Origination Form
Proposed Revisions to a Standard Plans Index

Originator:	Turley, Joshua	Index Number:	400-091
Date:	5/15/2025	Sheet Number(s):	Sheet 2
E-mail:	Joshua.Turley@dot.state.fl.us	Index Title:	APPROACH SLABS (30 FT.) (RIGID PAVEMENT APPROACHES)

Sheet 2: Converted starred notes to numerical notes. Adjusted the coping embed requirements for the top of the retaining wall in SECTION THRU APPROACH SLAB AND RETAINING WALL.

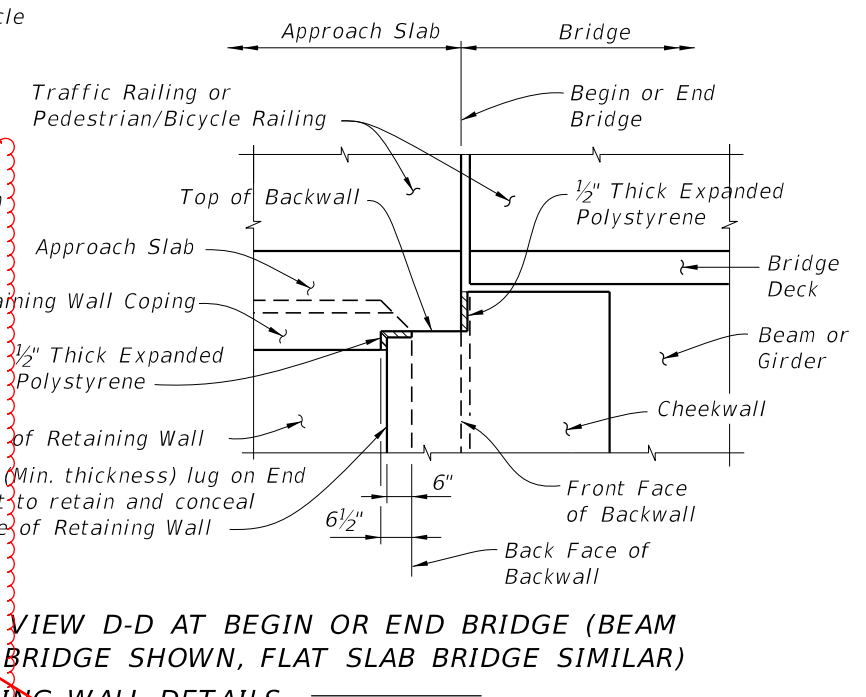
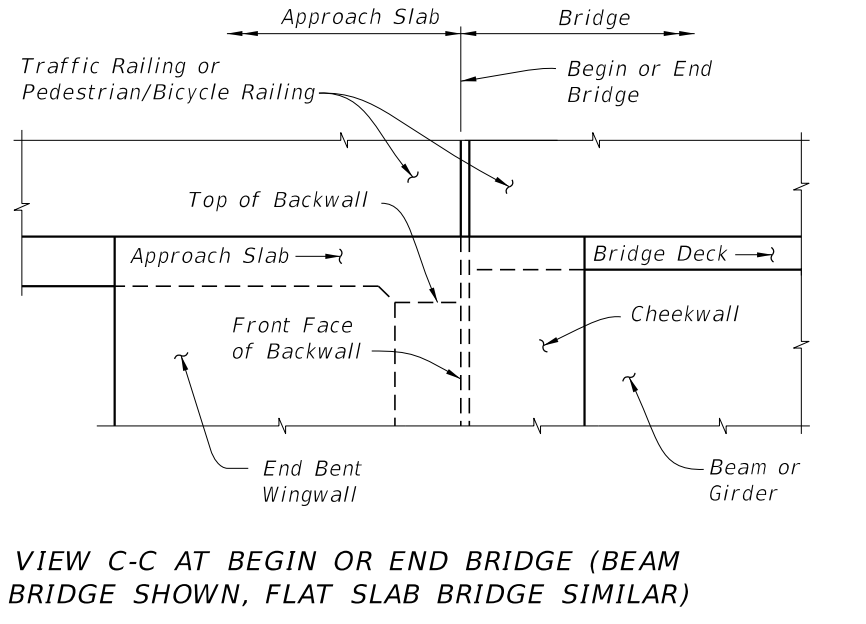
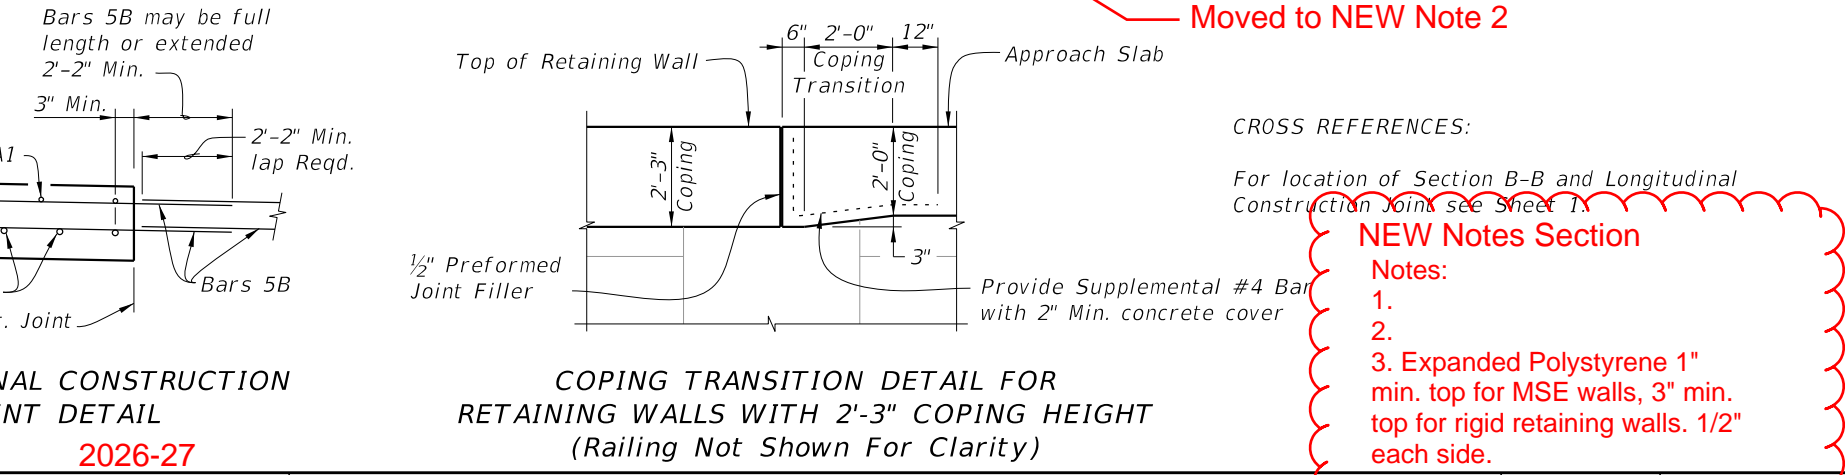
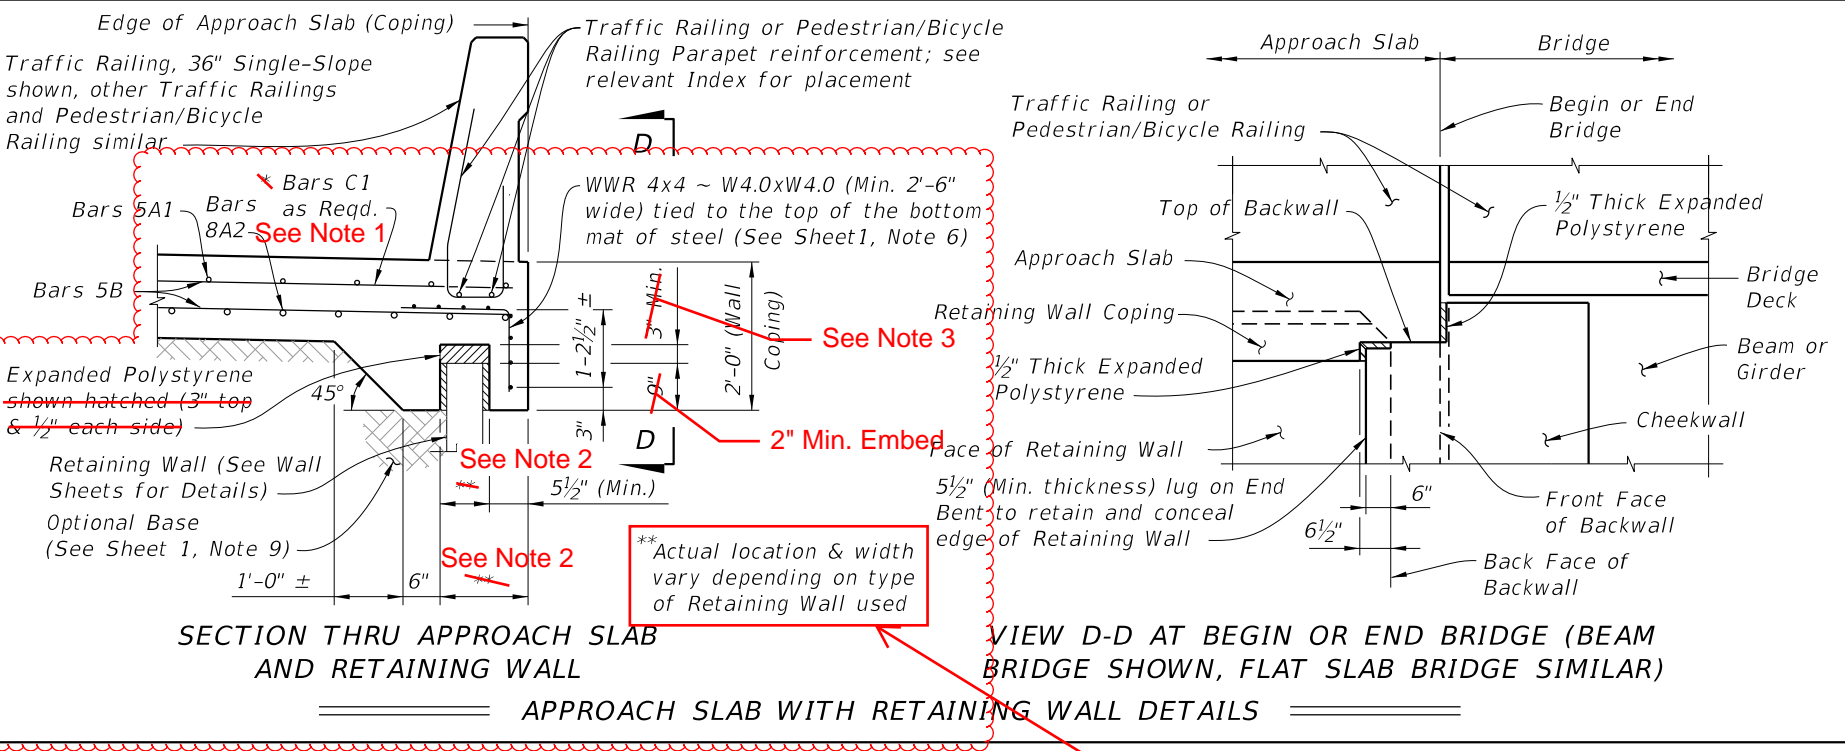
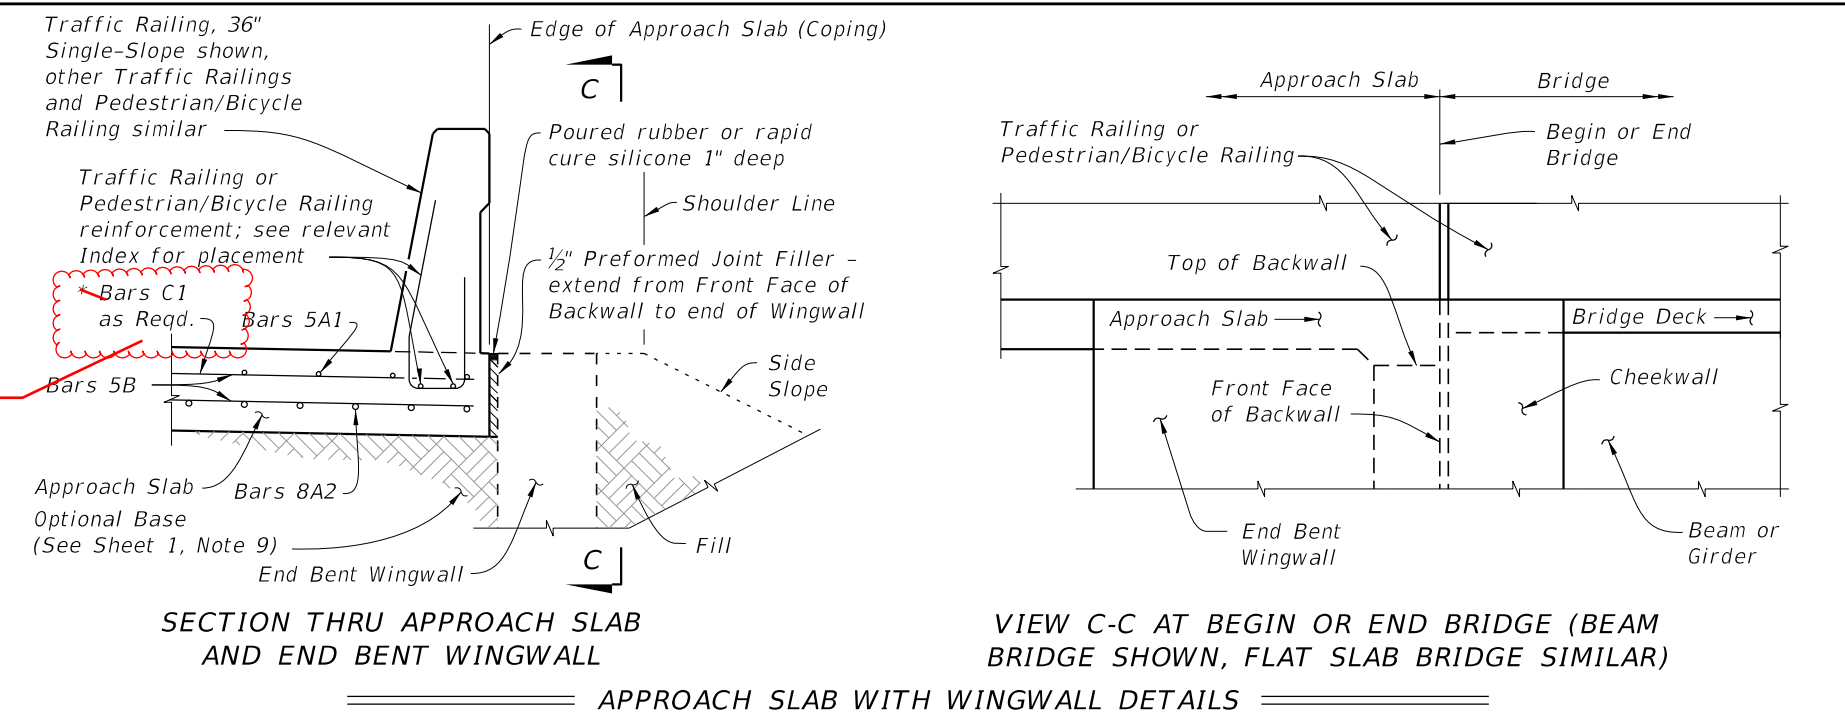
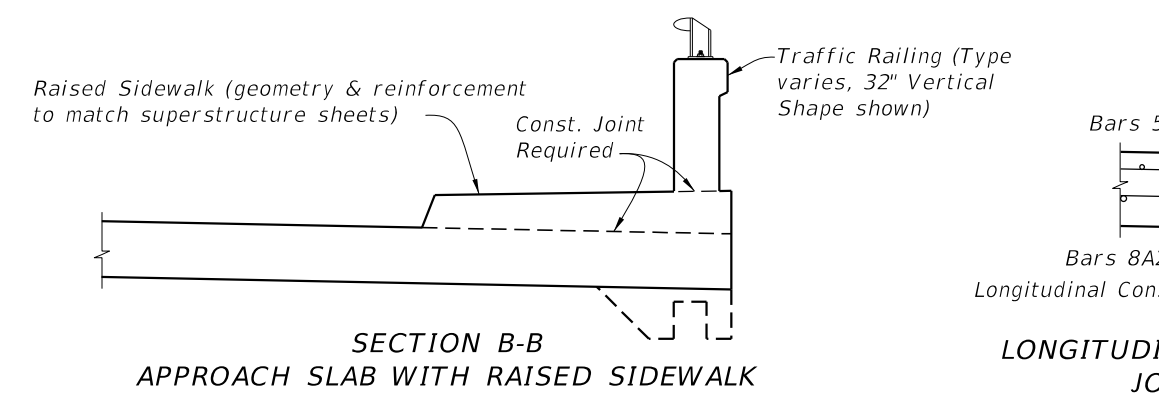
Moved to NEW Note 2

NEW Notes Section

- Notes:
- 1.
 - 2.
 3. Expanded Polystyrene 1" min. top for MSE walls, 3" min. top for rigid retaining walls. 1/2" each side.

**SECTION THRU APPROACH SLAB
AND RETAINING WALL**

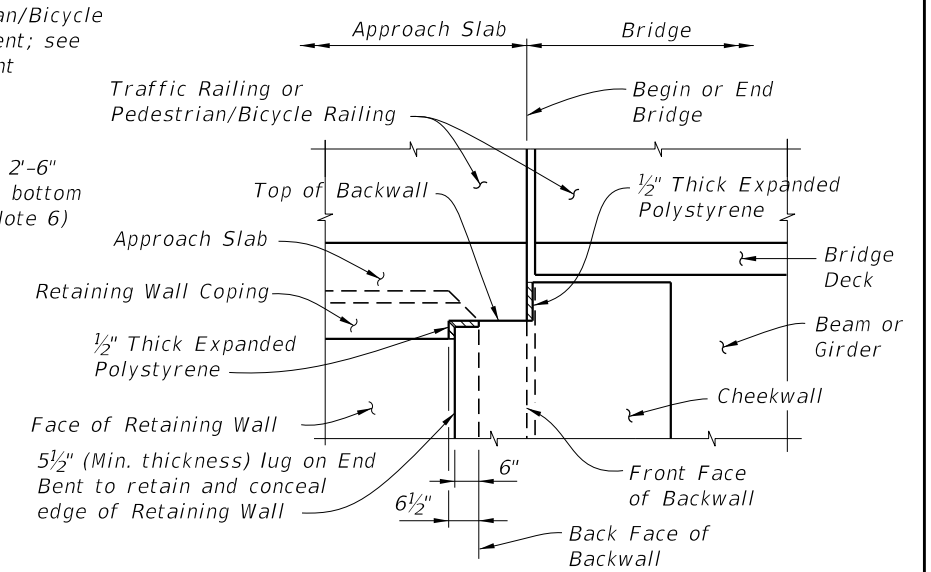
Contractors had trouble meeting top-of-wall elevations for MSE walls due to settlement issues. When predicted settlement didn't occur, walls were too high and required sawcutting. To address this, minimum thickness and embedment requirements for Expanded Polystyrene were relaxed, allowing better control over final wall elevations.

1. Bars C1 are required as shown when the 36" or 42" Single-Slope Traffic Railing, or the Traffic Railing/Noise Wall, are used at the edge of the Approach Slab.
2. Actual location & width vary depending on type of Retaining Wall used.
3. Expanded Polystyrene 1" min. top for MSE walls, 3" min. top for rigid retaining walls. 1/2" each side.
